STATE OF VERMONT
AGENCY OF TRANSPORTATION

PROPOSED IMPROVEMENT
BRIDGE PROJECT

TOWN OF RIPTON
COUNTY OF ADDISON

RECORD PLANS

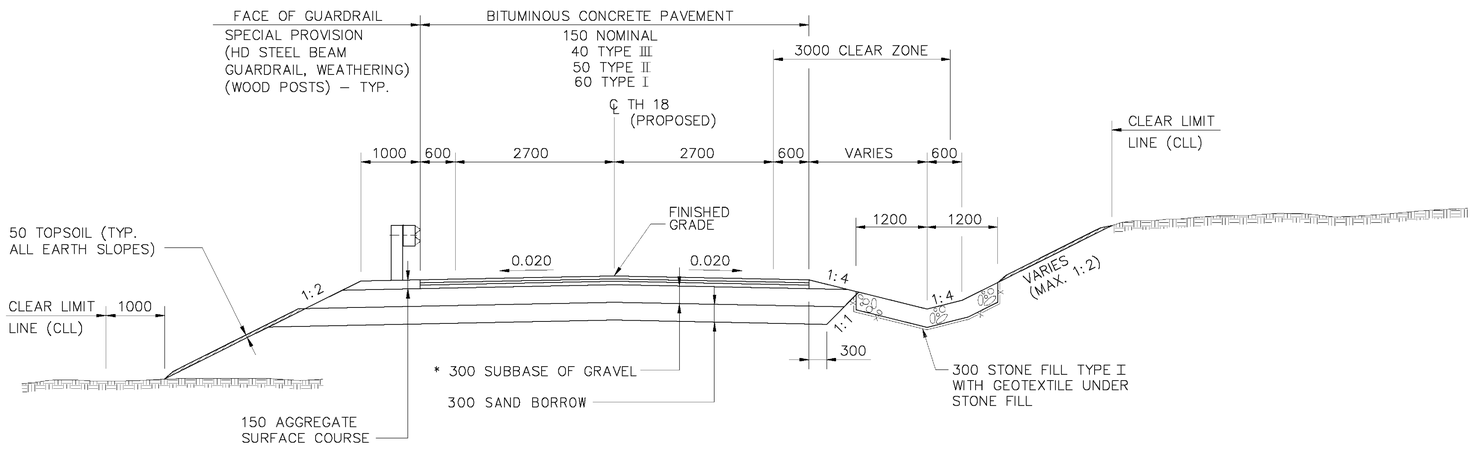
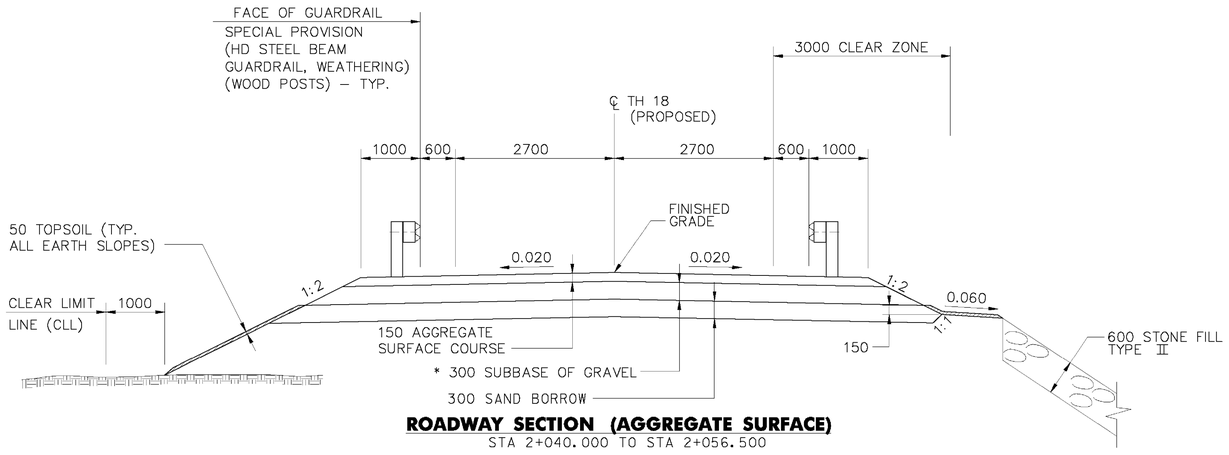
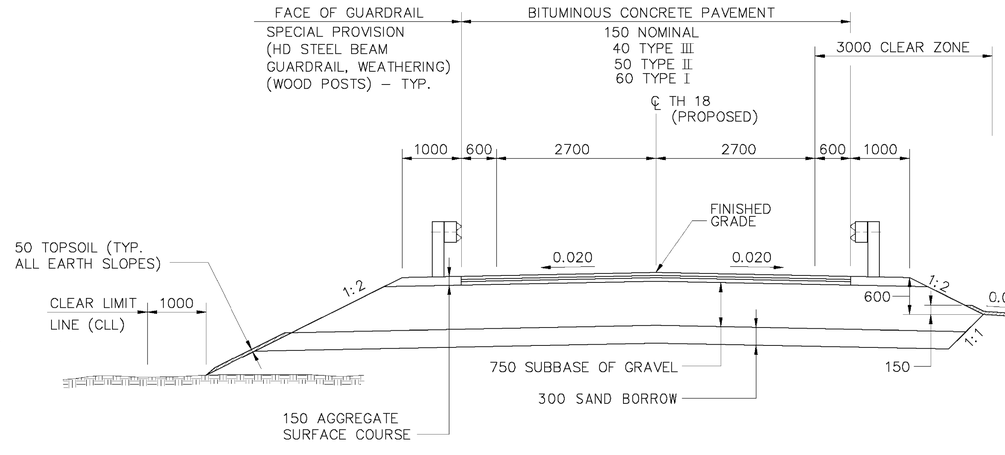
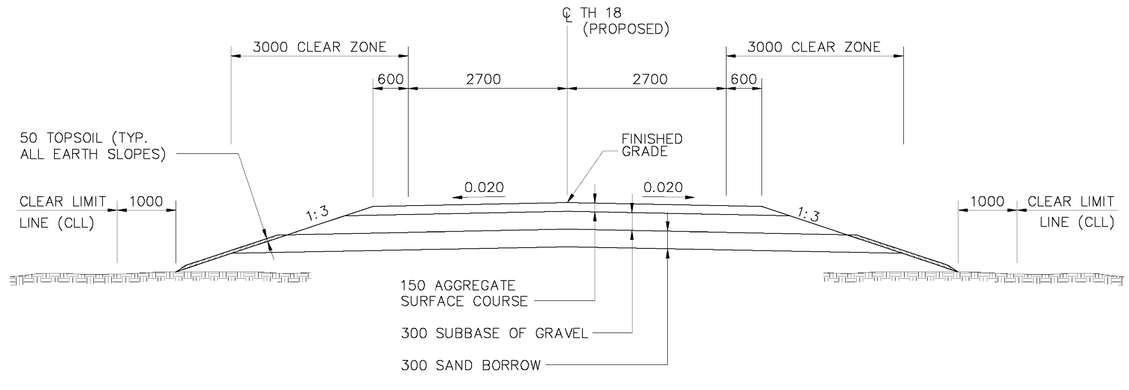
ADDED ADDITIONAL TYPICAL SECTIONS.
REVISED ROADWAY SLOPES FOR GUARDRAIL AND STONE FILL.

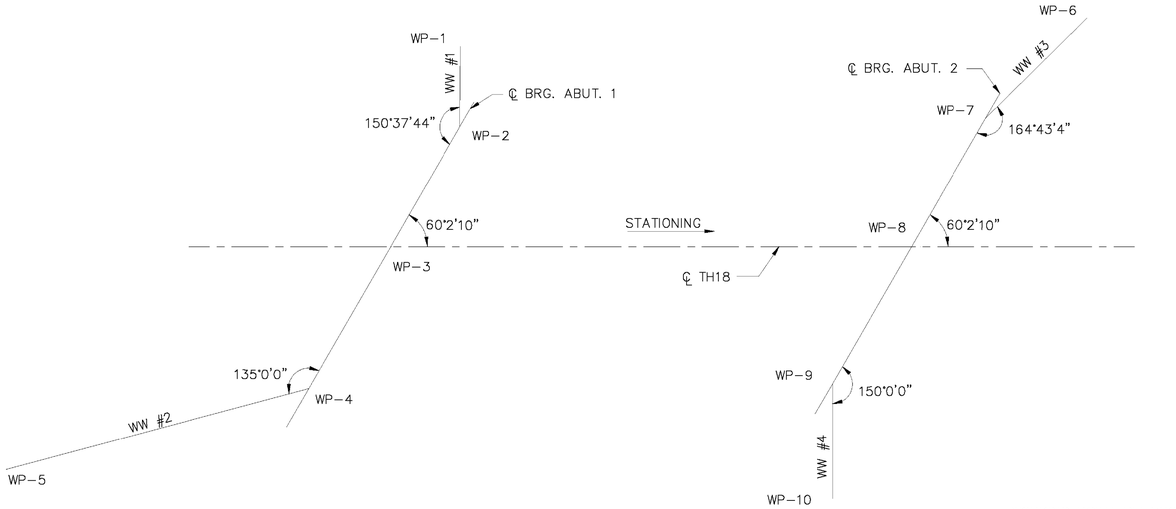
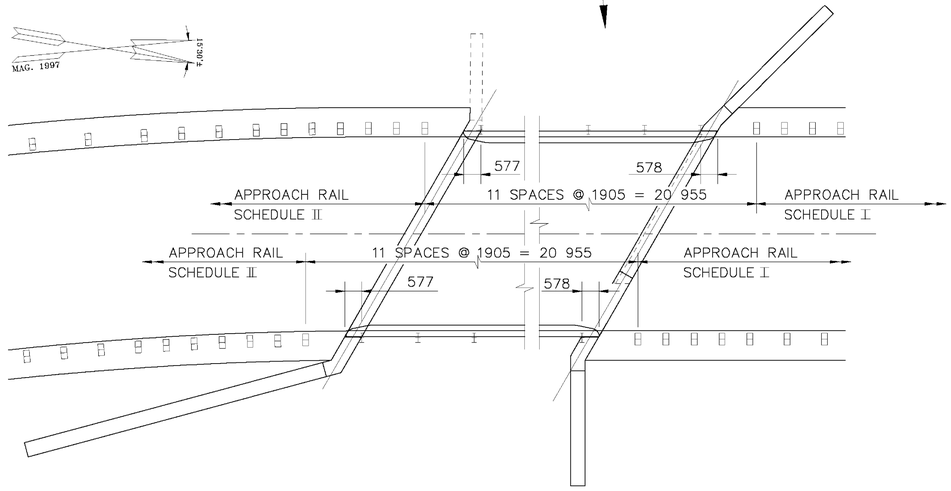
REVISED WINGWALL 2.

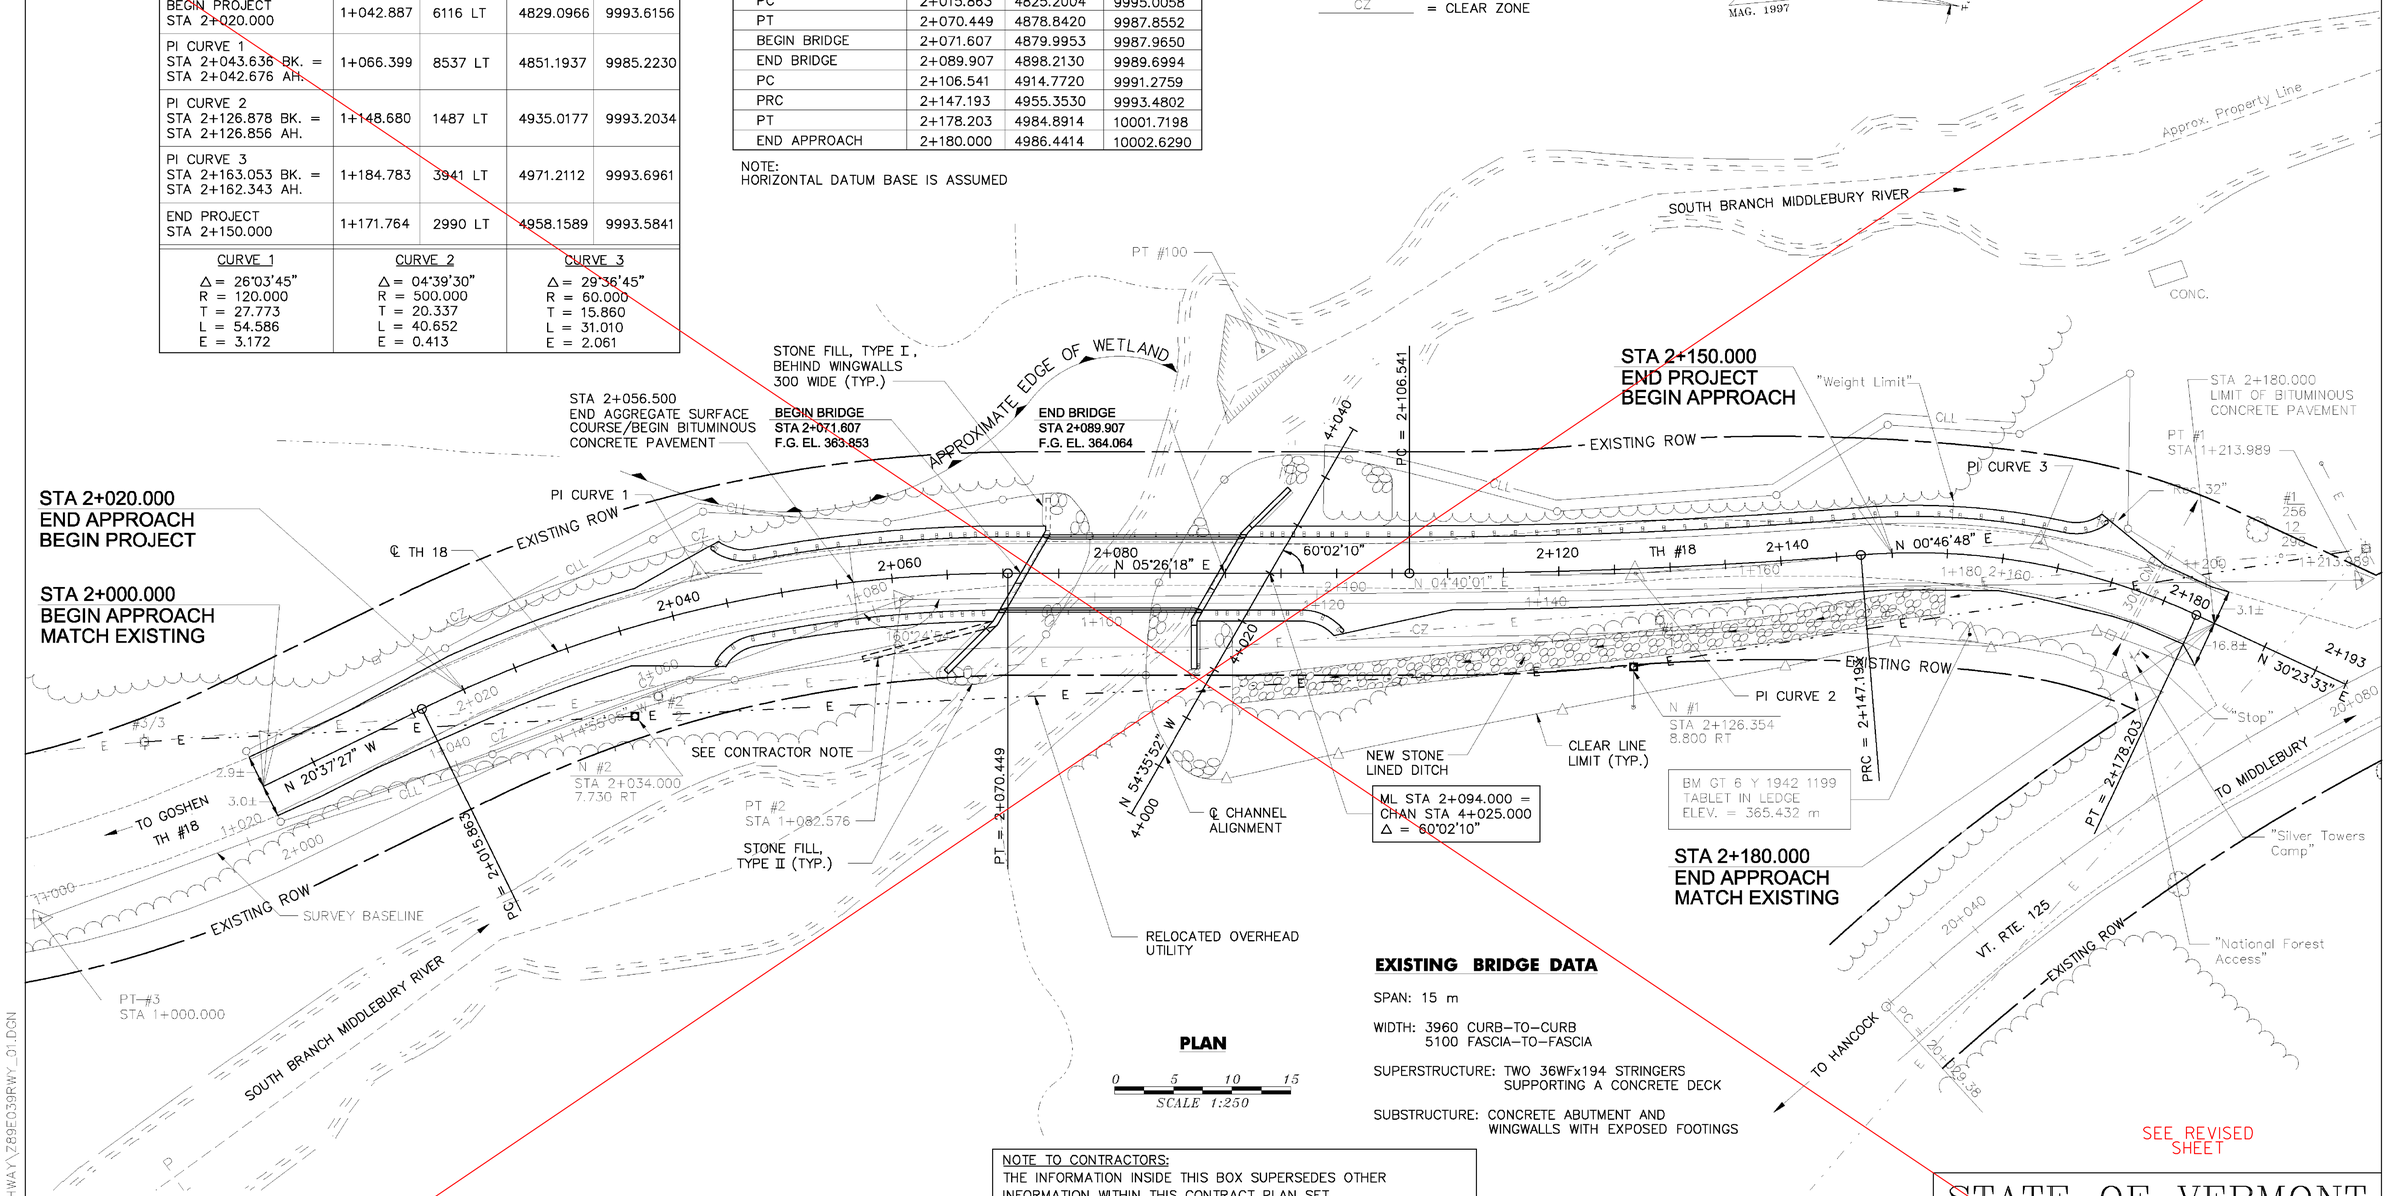
1. WINGWALL #2, STAT. 2+065 RT. (UPSTREAM RIGHT SIDE) IS GOING TO BE LENGTHENED (APPROX. 6m) ONCE ADDITIONAL SURVEY IS TAKEN. YOU SHALL ASSUME THAT THE BOTTOM OF FOOTING ELEVATION WILL STAY THE SAME. SEE ESTIMATED LOCATION ON THIS SHEET. ESTIMATED QUANTITIES HAVE ALREADY BEEN ADDED TO THE QUANTITY SHEET AND ESTIMATE TO REFLECT THIS.
2. WE ANTICIPATE ADDITIONAL STONE FILL TYPE II FOR 30m ALONG THE SLOPE WILL BE USED. ADDITIONAL QUANTITIES OF UNCLASSIFIED CHANNEL, STONE FILL, TYPE II AND GEOTEXTILE UNDER STONE FILL HAVE ALREADY BENN ADDED TO THE QUANTITY SHEET AND ESTIMATE.
3. THE TEMPORARY PEDESTRIAN BRIDGE WILL NOW BE LOCATED ON THE DOWN STREAM SIDE, INSIDE THE EXISTING ROW, AND SPANNING BEHIND THE EXISTING WINGWALLS WITHOUT IMPACTING WETLANDS NEAR WINGWALL #1.

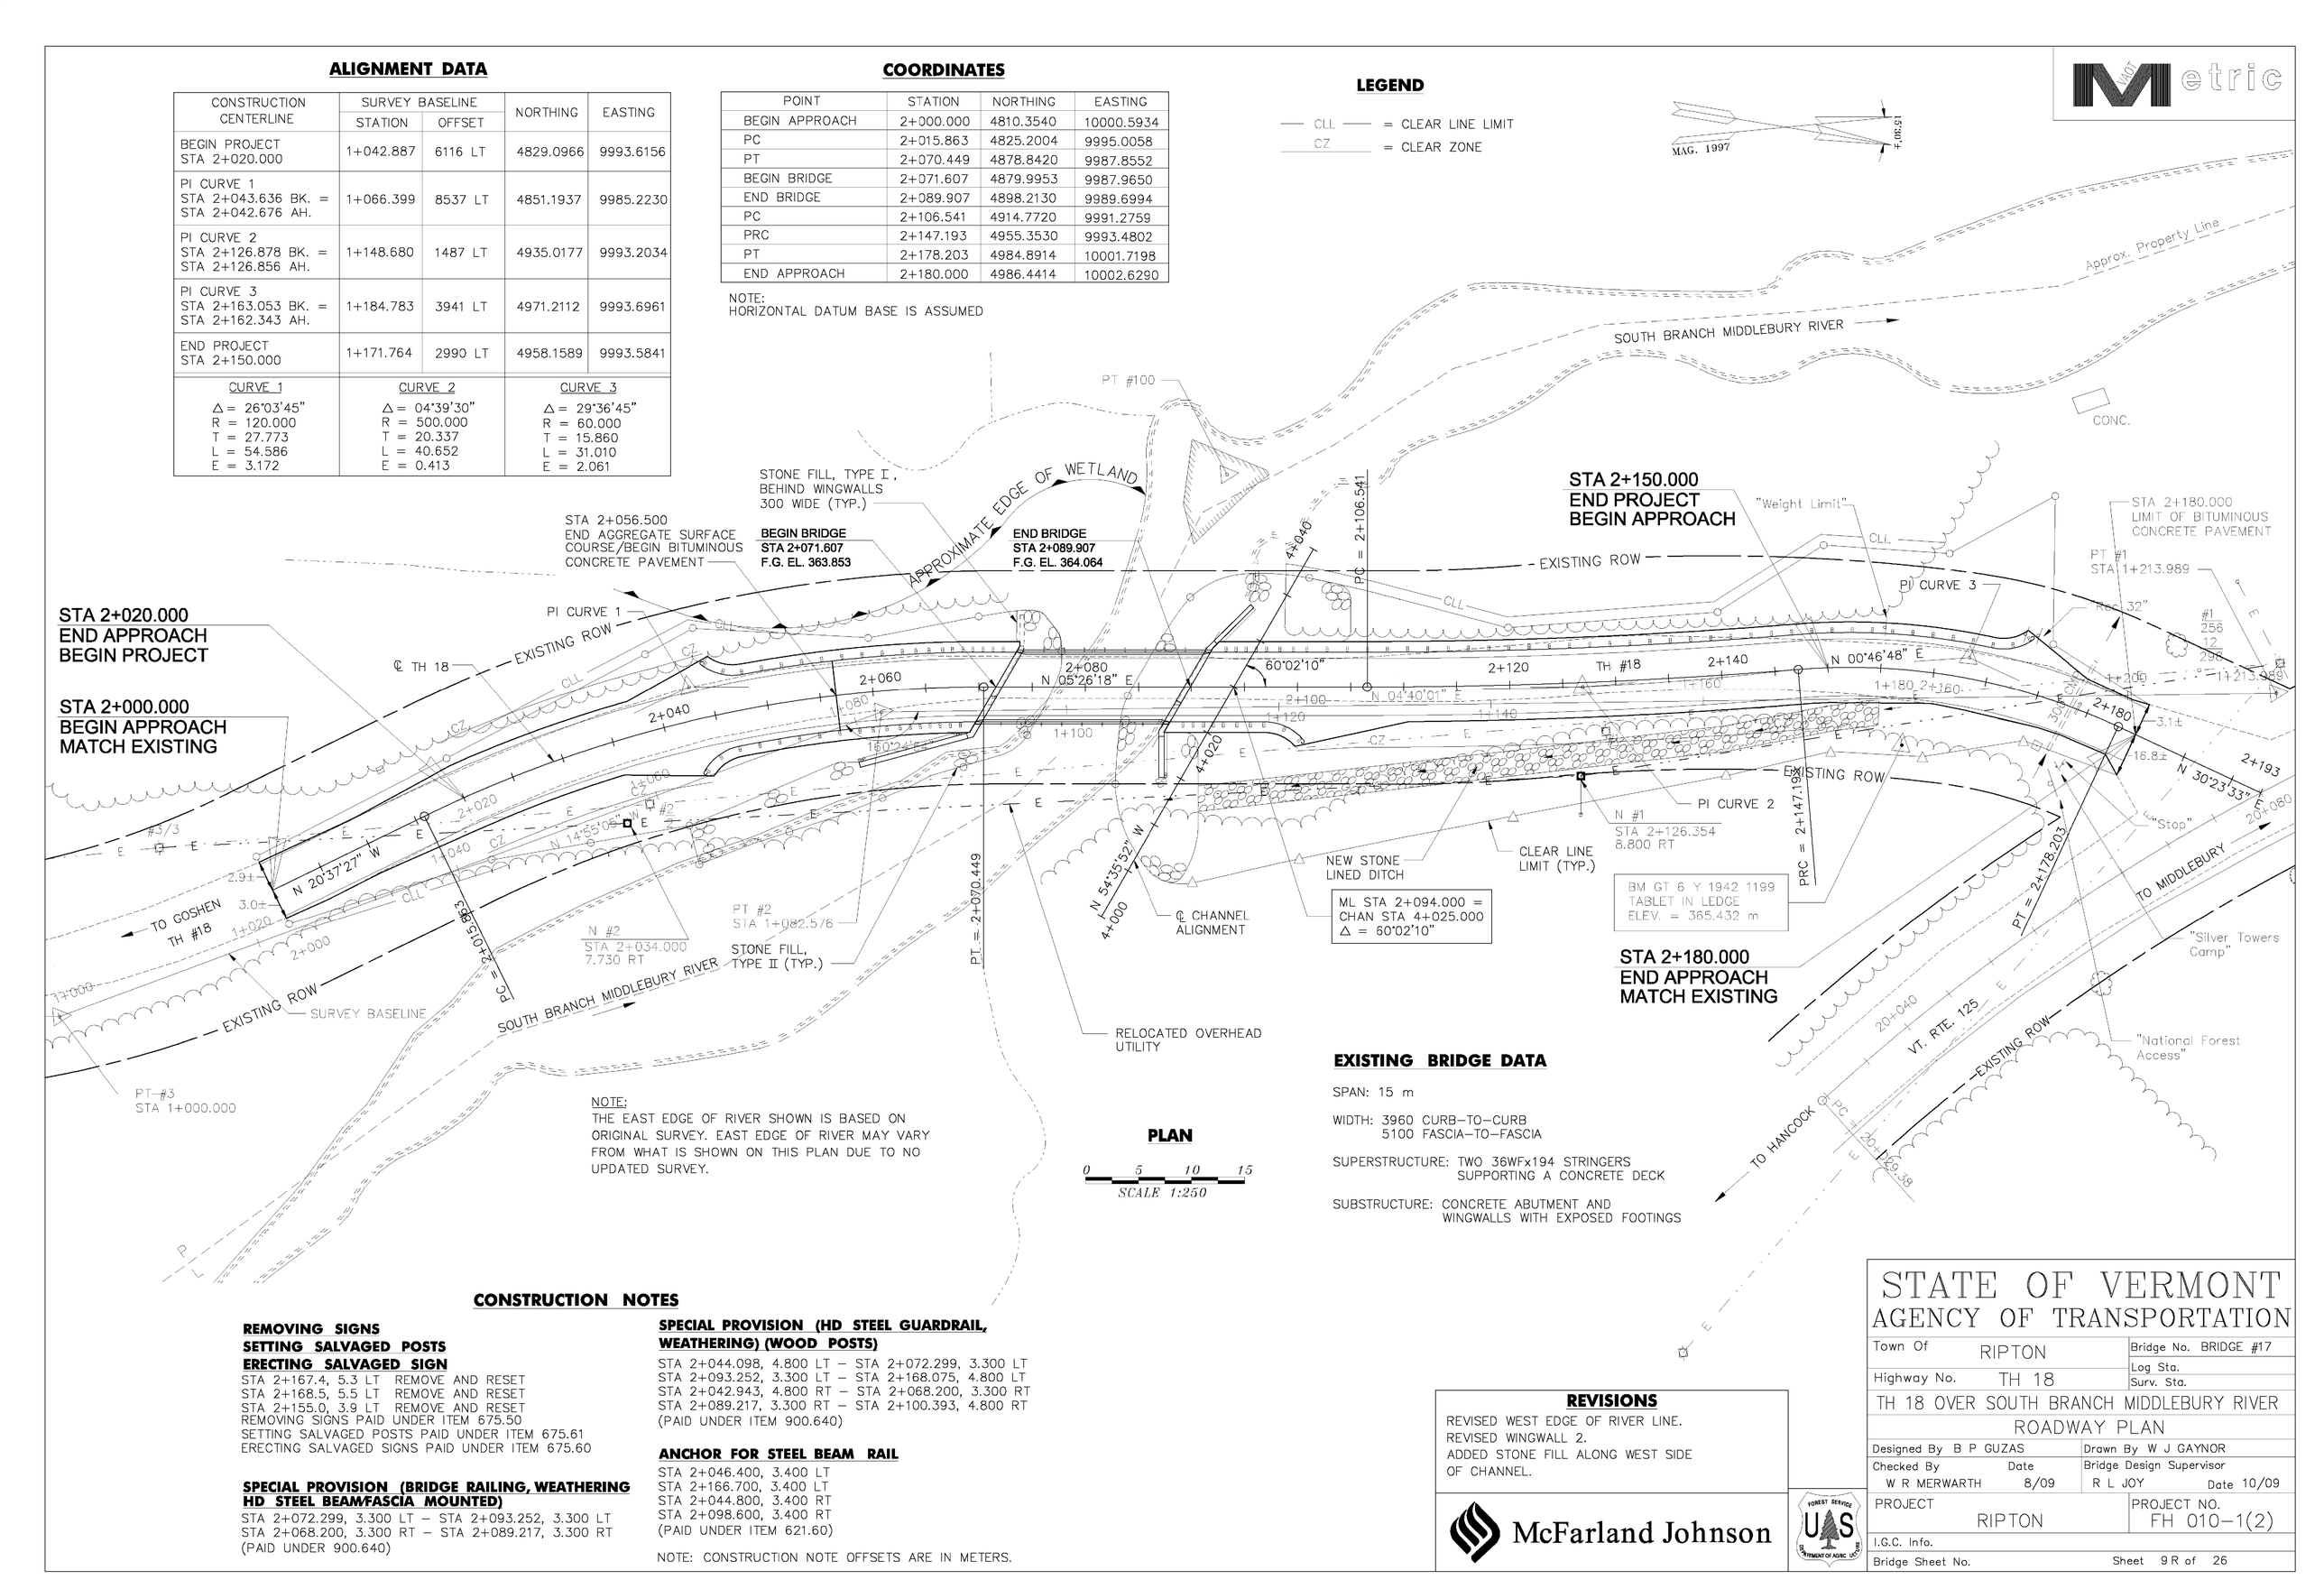
REVISIONS
REVISED WEST EDGE OF RIVER LINE.
REVISED WINGWALL 2.
ADDED STONE FILL ALONG WEST SIDE OF CHANNEL.
